APPENDIX D

COORDINATION DOCUMENTATION

**Re: Modifications to the Interim Operations and Exceptional Drought
Operations Plans**

Description of Proposed Action
Modification to the Interim Operations Plan at Jim Woodruff Dam

Figure 16. Percentage of the Main Channel of the Apalachicola River Entering Chipola Cutoff from 1976 to 2004. From Administrative Record in *State of Georgia v. U.S. Army Corps of Engineers* (M.D. Fla. 07-cv-1) GAII001733.

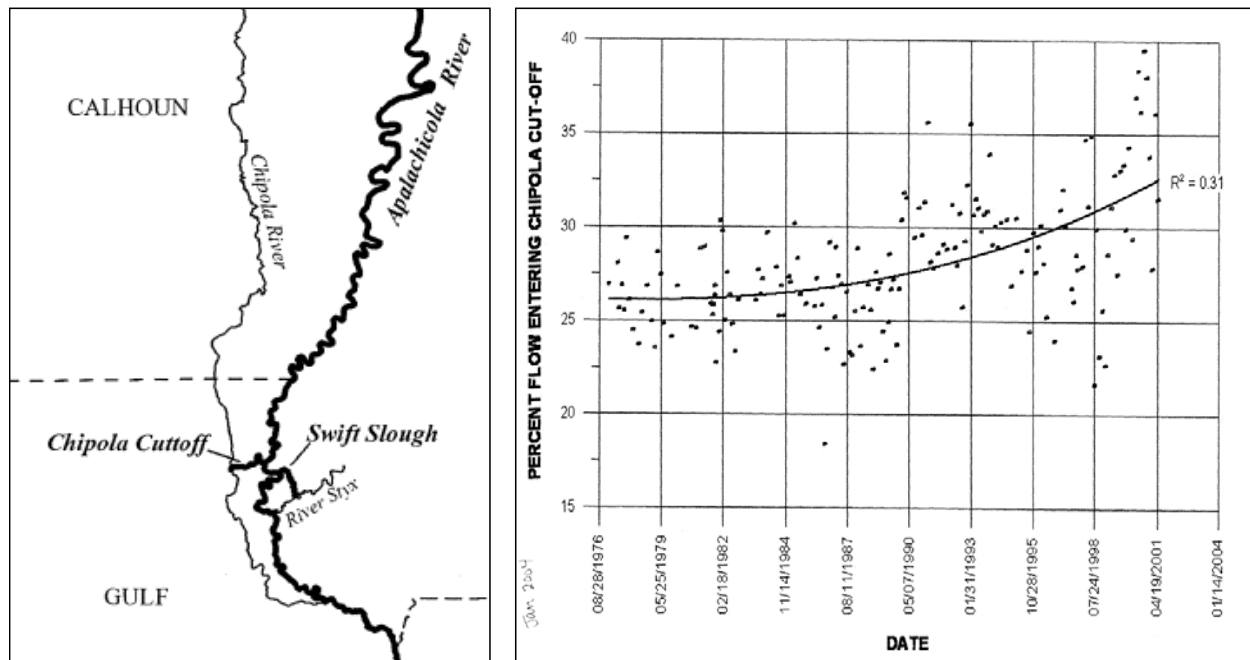
Likewise, the Apalachicola River appears to be migrating to the Chipola Cut-off, a man-made diversion that is claiming up to 40% of the flow of the mainstem of the river, according to the most recent statistics. This diversion is partially responsible, along with other factors such as the build-up of sediment at the head of the slough—for the dewatering of Swift Slough in 2006 and 2007. Water-use in the metro area pales in comparison to the amount diverted by this artificial cut-off. See Figure 16.

Figure 1: IOP Woodruff release requirements and dry-year (2000) Basin Inflow

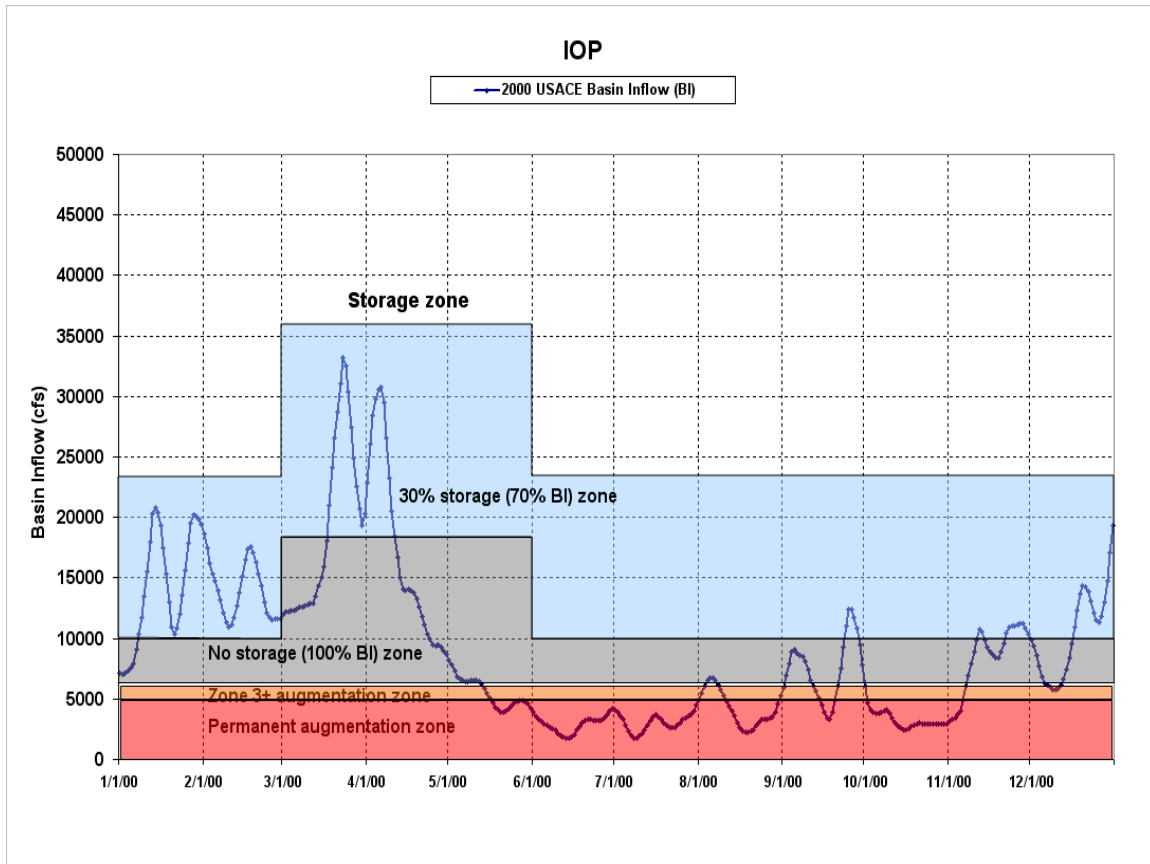
A major weakness of the IOP/MIOP framework is evident in Figures 1 and 2, graphically depicting IOP BI release requirements in conflict with WCP rule curves and zones designed to induce seasonal conservation storage drawdown and refill during dry years (2000 in this example).

Figure 7: ACF system storage imbalance produced by IOP/EDO operations, April 2008

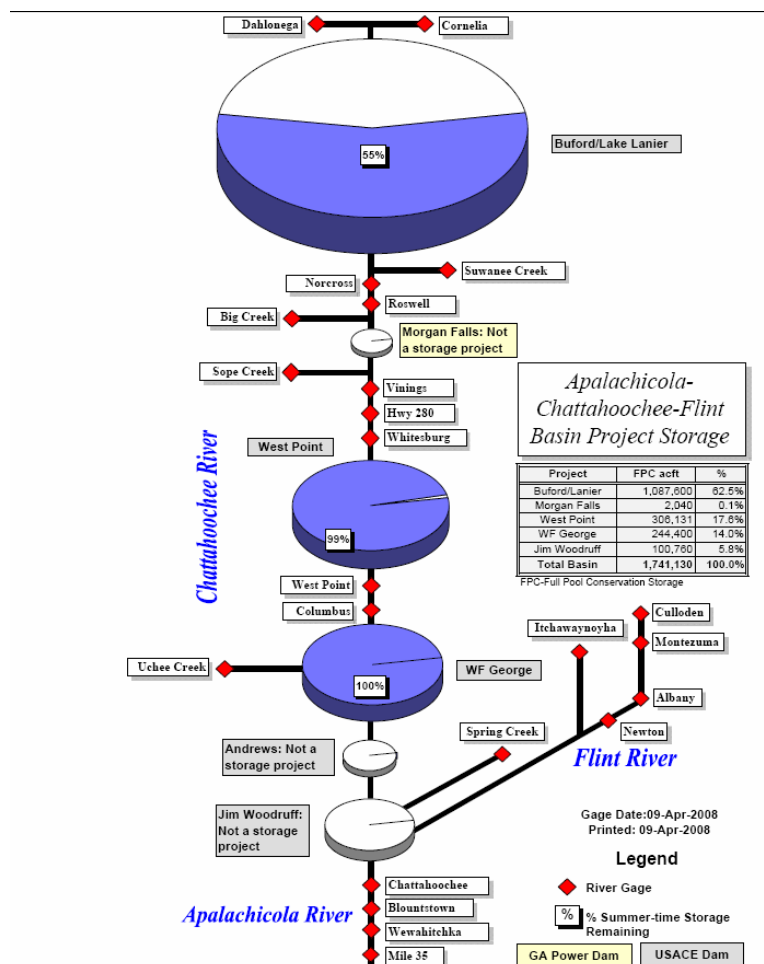
As previously described, the spring flow augmentation requirements under the IOP and MIOP conflict with the WCP objective to store high spring flows in advance of the normally-dry summer and fall months. In addition, however, the IOP and MIOP impose higher summer and fall minimum release requirements than the WCP. As a result, Lanier – the reservoir with annual carryover storage – is afforded less opportunity to refill than the smaller downstream reservoirs, creating an imbalance in system storage as experienced this spring, shown in Figure 7.

Figure 8: Lanier observed daily pool elevation, 1980–2007

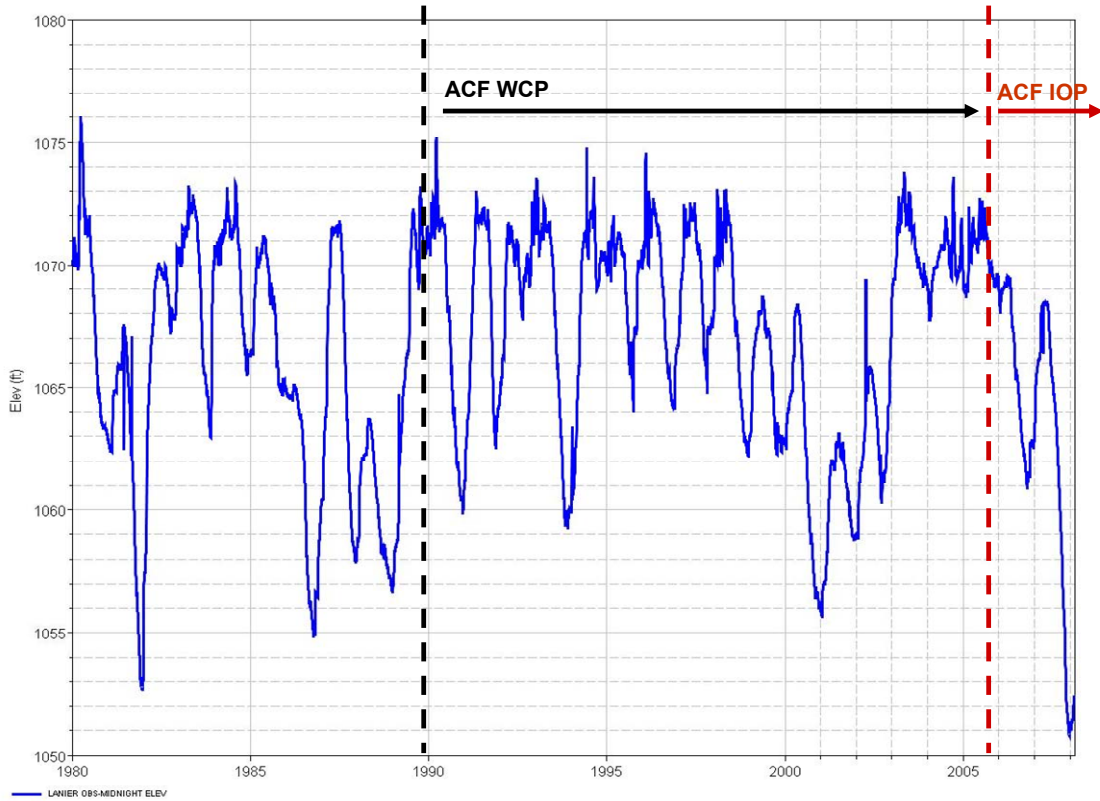
The significant departure of IOP-prescribed reservoir releases from the WCP apparent by examination of the operational data and comparison with system performance in previous basinwide droughts. Figure 8 displays Lanier daily pool elevations, observed prior to the WCP (1980–1990), under the WCP beginning in 1990, and under various iterations of the IOP beginning in 2006. Three regional multi-year droughts occurred during this 28-year span – 1980–1981, 1986 – 1989, 1998–2001, and 2006–2007 (ongoing). The 1980–1981 drought was relatively short but intense, producing the lowest lake level since Lanier was originally impounded in 1957. Operational adjustments were made to reduce the drawdown from 1986–1988, which at present still constitutes the lowest 3-year inflow period in Lanier’s history. These adjustments were formalized in the 1989 WCP and served to comparatively reduce Lanier drawdown during the subsequent 1998–2001 4-year drought.
